Determination 2016/043

Regarding the compliance of weatherboards as installed to a house at 14 Te Whangai Head Road, Pataua North, Whangarei

Figure 1: Weatherboard profiles

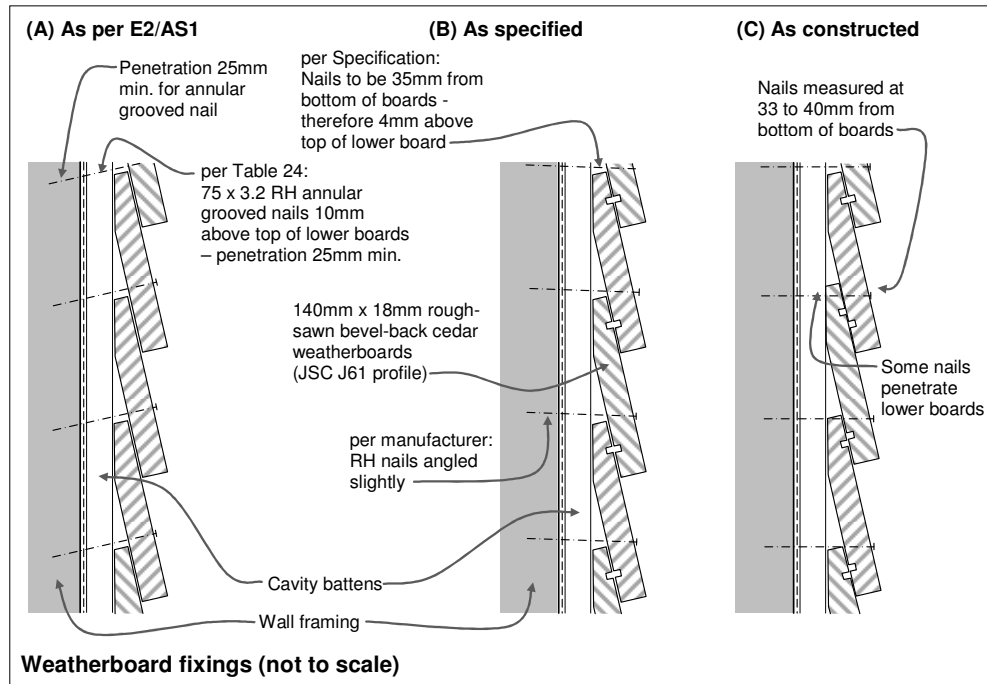
- 2.3.4 Figure 1(B) shows the profile of the installed weatherboards. This is compared to the board profile shown in Figure 1(A), which is that described in Acceptable Solution E2/AS1:

4.6.6 In response to the owner’s contention with respect to non-compliance with E2/AS1: the weatherboards used are not as described in E2/AS1 (refer Figure 1) and the means of installation as specified in the consent is also not consistent with E2/AS1. In my view these variations, of themselves, cannot be used solely to determine whether the cladding satisfies the mandatory performance requirements of the Building Code.
